FIELD INSPECTION

Project Name:	Mountain Valley Pipeline	Inspector:	Matthew Grant
Inspection Date:	Tuesday, October 16, 2018	Project Contact:	Brian Clauto
Spread: Franklin County MP 263 St#130903-13938	Spread I	Weather (Wet/Dry/Rain):	Wet

FIELD INSPECTION PHOTO LOG

Fig. 1
The area between 13903 and St#13926 lacks stabilization.

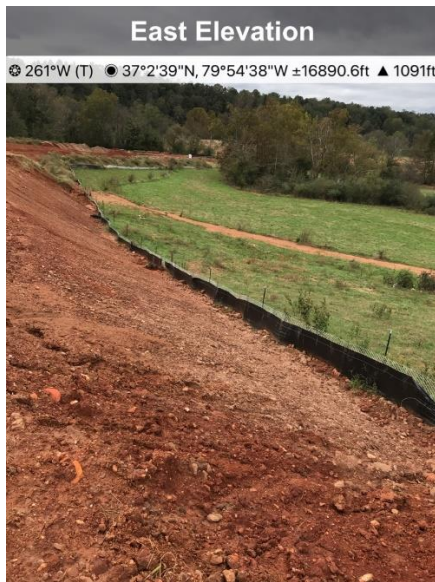
- **Area 1** –MP 263 St#13903-13938 Observations: no work was being conducted in the wetlands or streams within this area per the Nationwide Permit 12 Verification Suspension letter dated 10/5/18. The area between St#13903 and St#13926 lacks stabilization, at St#13903+00 sediment has left the ROW. At St#13916+23 debris is outside of ROW, which had been noted in the SWPPP by MVP.

Recommended Corrective Action: Stabilized slope between stations 13903 and 13926 and remove sediment per DEQ approval.

Deadline: Within 24 hr notification
